Item Name: Aft Crosstube - Extended Height 31"

DART AEROSPACE LTD		Work Order:	131755
Description: Crosstube High-High Aft		Part Number:	D205-596-107
Inspection Dwg: D205-596-107 Rev: B		Page 1 of 1

DRAWING NO. D205-596-107	TITLE CROSSTUBE ASS'Y, HI-HI AFT	REV. B	DART AEROSPACE LTD ENGINEERING ORDER		D.E.O. NO. D205-596-107-B-2	SHEET NO. SHEET 1 OF 1	SCALE NTS
DRAWN <i>9</i>	CHECKED <i>A.P.</i>	MFG. APPR. <i>A</i>	APPROVED <i>MD</i>		DE APPR. <i>MD</i>		
DATE 13.11.11	DATE 13.11.19	DATE 13.11.19	DATE 13/11/21		DATE 13/11/21

DRAWING NO. D205-596-107	TITLE CROSSTUBE	REV. B	DART AEROSPACE LTD ENGINEERING ORDER		D.E.O. NO. D205-596-107-B-3	SHEET NO. SHEET 1 OF 1	SCALE NTS
DRAWN <i>q</i>	CHECKED <i>A.P.</i>	MFG. APPR. <i>AA</i>	APPROVED <i>AS</i>		DE APPR. <i>th</i>		
DATE 15.01.15	DATE 15.01.20	DATE 15.01.20	DATE 15.01.20		DATE 15.01.20

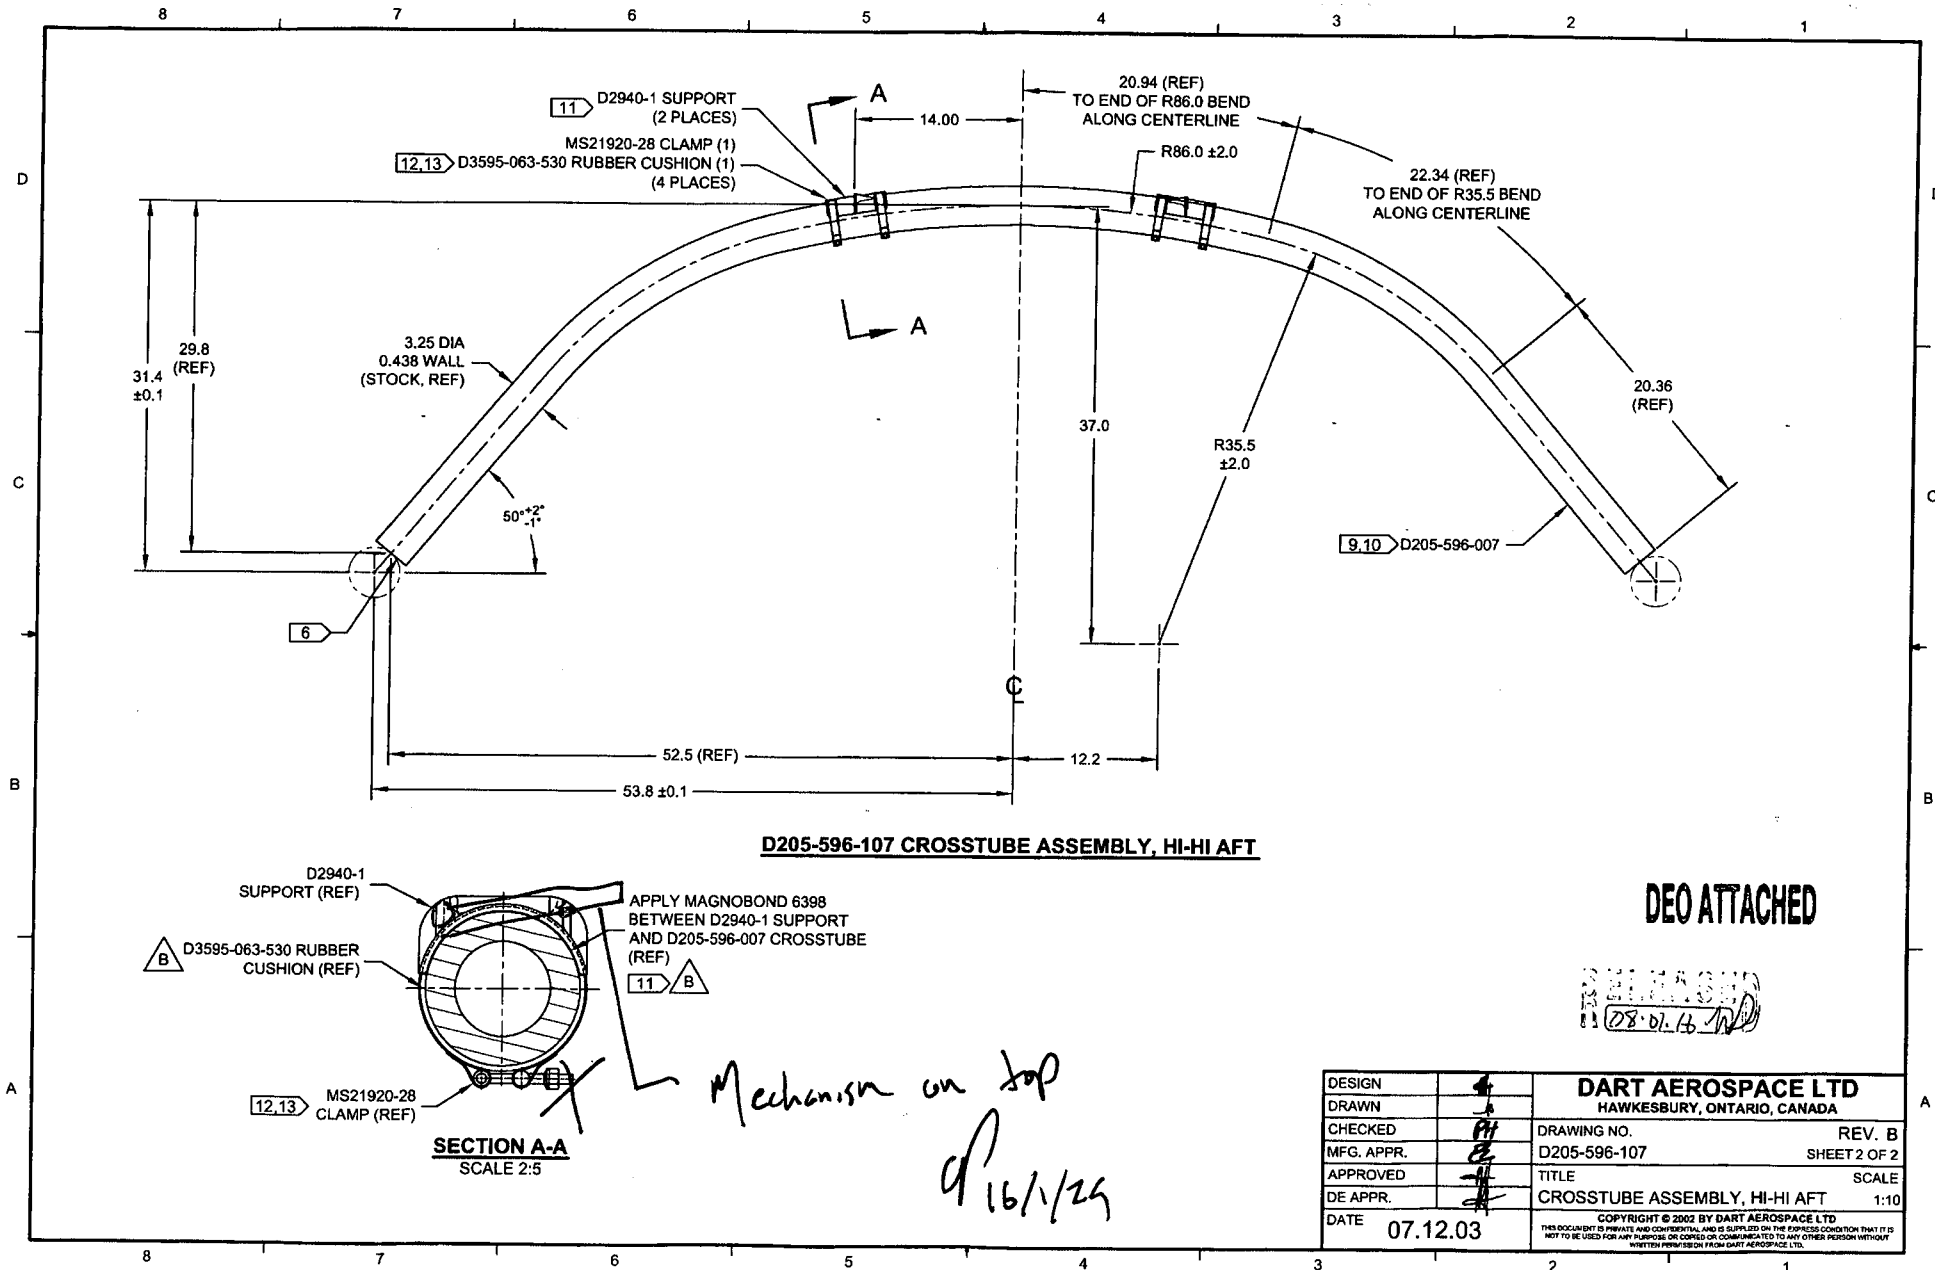
REPLACE MAGNOBOND WITH PROSEAL.

Qty	Part Number	Description
A/R	PROSEAL 890 B-2	SEALANT, AMS-S-8802 CLASS B-2

A/R	MAGNOBOND 6398	ROCKWELL SPECIFICATION RBO-120-023 ADHESIVE (TEXTRON/BELL SPEC. 299-947-100, TYPE II, CLASS 2 ADHESIVE)
-----	----------------	---

NOTE 11 & 13, SHEET 1 IS AMENDED AS FOLLOWS:

- 11) APPLY A 0.03" TO 0.06" THICK LAYER OF MAGNOBOND 6398 TO THE SURFACE OF D2940-1 THAT WILL BE IN CONTACT WITH THE CROSSTUBE. LET CURE FOR 12 HOURS AFTER INSTALLATION AND PRIOR TO PACKAGING.
- 13) TORQUE CLAMPS 80 TO 100 IN-LB.

- 11) TO INSTALL D2940-1 SUPPORT: ABRASE MATING SURFACE OF SUPPORT AND CROSSTUBE WITH 180-GRIT SANDPAPER AND REMOVE RESIDUE WITH MEK (OR EQUIVALENT). APPLY A 0.04" TO 0.07" THICK LAYER OF PROSEAL 890 CLASS B-2 (OR AMS-S-8802 CLASS B-2) SEALANT TO MATING SURFACE OF SUPPORT.
- 13) TORQUE CLAMPS 80 TO 100 IN-LB. ENSURE AT LEAST 1.5 THREADS SHOWING IN SAFETY AND THAT NUT HAS NOT BOTTOMED-OUT AFTER TORQUING. **PRIOR TO PACKAGING, RE-CHECK TORQUE ON CLAMPS AFTER PROSEAL 890 SEALANT HAS CURED FOR 72 HOURS.**

FIGURE 1 - SUPPORT INSTALLATION

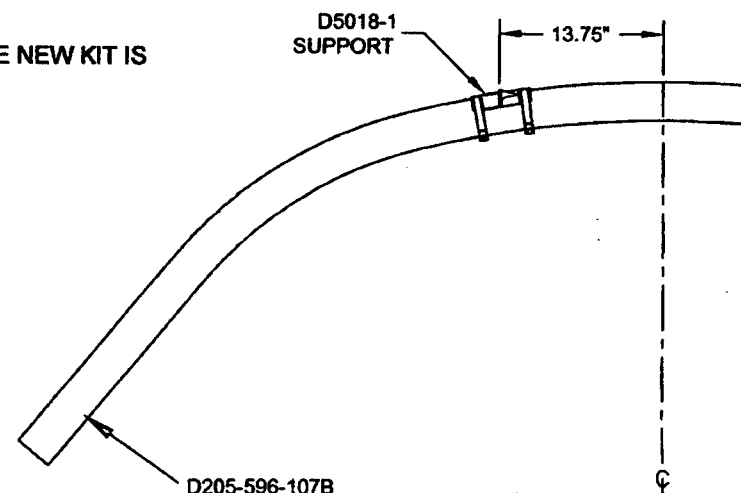
ADD THE FOLLOWING CROSSTUBE ASSEMBLY:

Qty	Part Number	Description
X	D205-596-107B	CROSSTUBE ASSEMBLY (214 HI-HI AFT)

THE D205-596-107B CROSSTUBE HAS THE SAME PARTS LIST AS THE D205-596-107 CROSSTUBE EXCEPT AS FOLLOWS:

2	D5018-1	SUPPORT
---	---------	---------

2	D2940-1	SUPPORT
---	---------	---------

INSTALL THE SUPPORTS AS SHOWN IN FIGURE 1 OF THIS ENGINEERING ORDER. THE NEW KIT IS OTHERWISE ASSEMBLED PER THE D205-596-107 CROSSTUBE.
